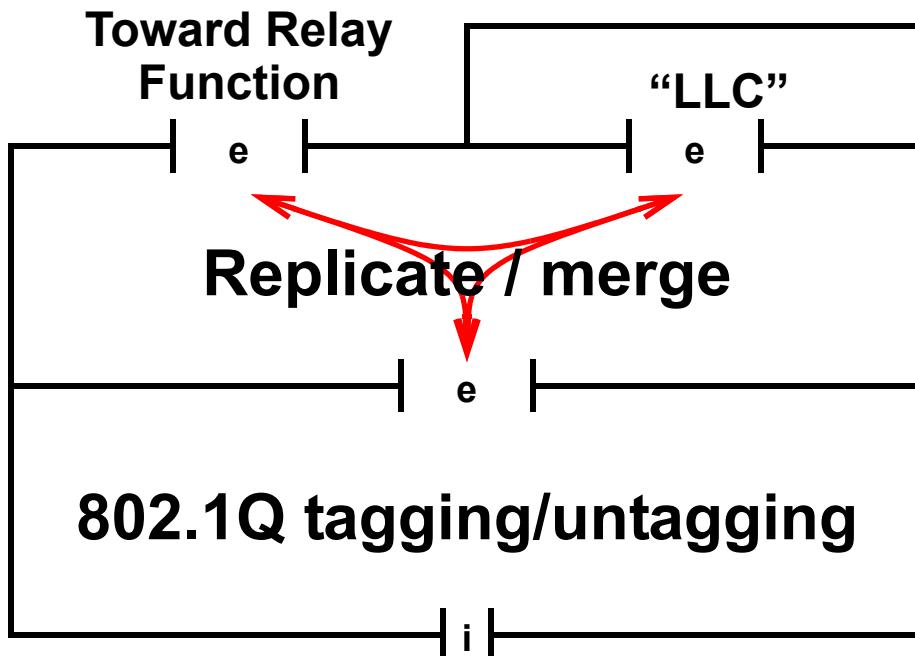
This version doesn't allow for an EISS to the upper layers (brain):

The LLC has no access to the “raw” data stream except by using VLAN 0 or 0xFFFF to mean, “untagged” in the tagging/untagging function. Worse, the LLC cannot enforce the rule that BPDUs be untagged:

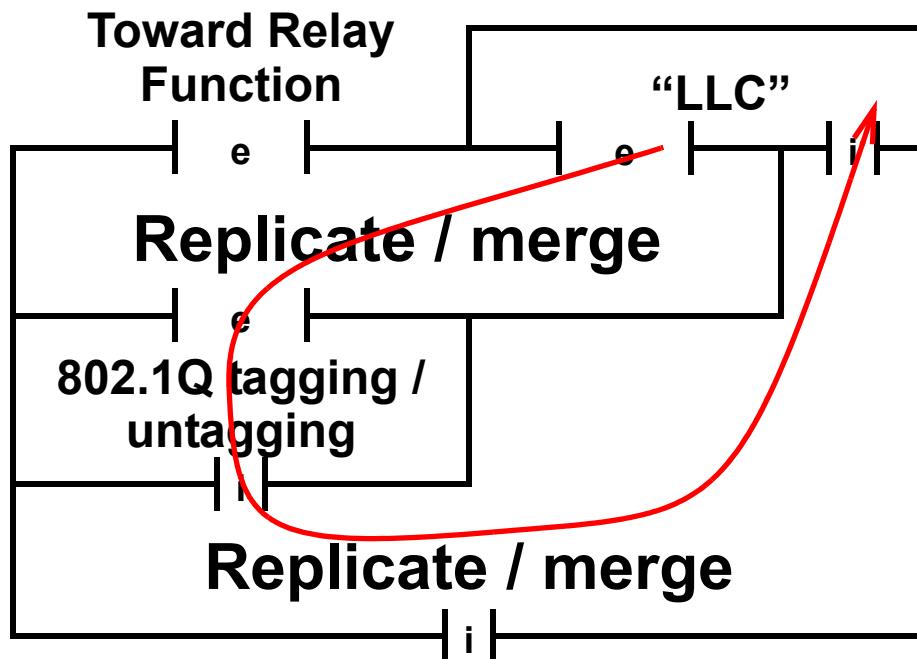
This version is rather complex:, but loops back emitted LLCs!

But, we can fix this:

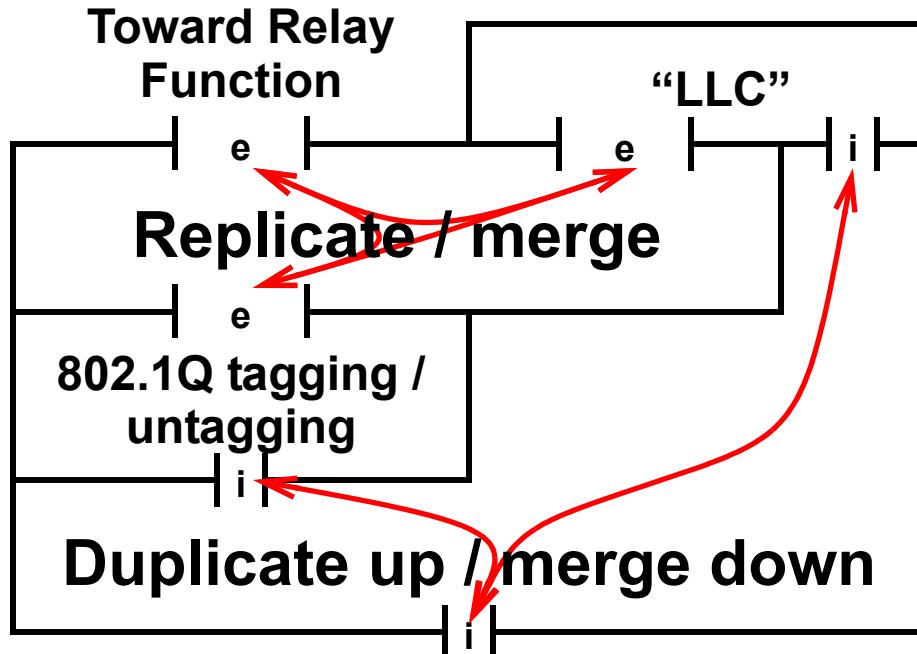
Now, we add the AIS CF. Horribly complex, but it seems to do the right thing. Can it be simplified?:
